# COUNTY OF HENRICO

> > RE: POD2023-00493

Wrighthaven Square Apartments at Libbie

Mill Midtown Original POD

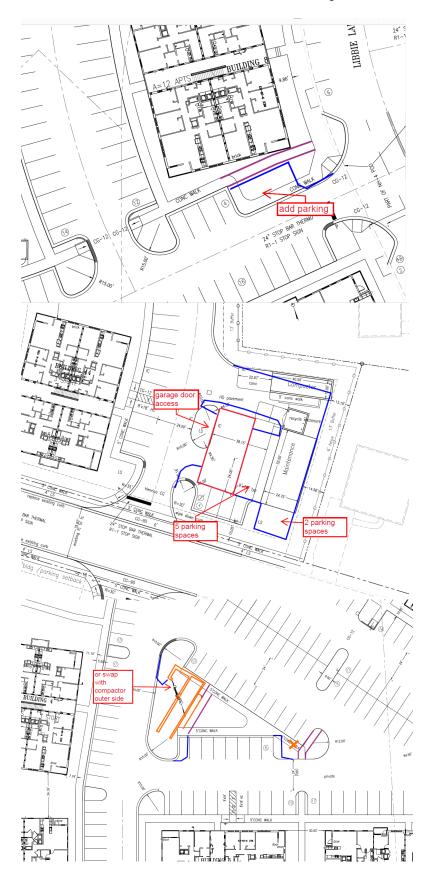
- 5) The maintenance building should have just one driveway cut from the parking drive aisle, or may be designed for service doors to access directly onto the drive aisle. Consider alternatives in the attached sketches to remedy the situation.
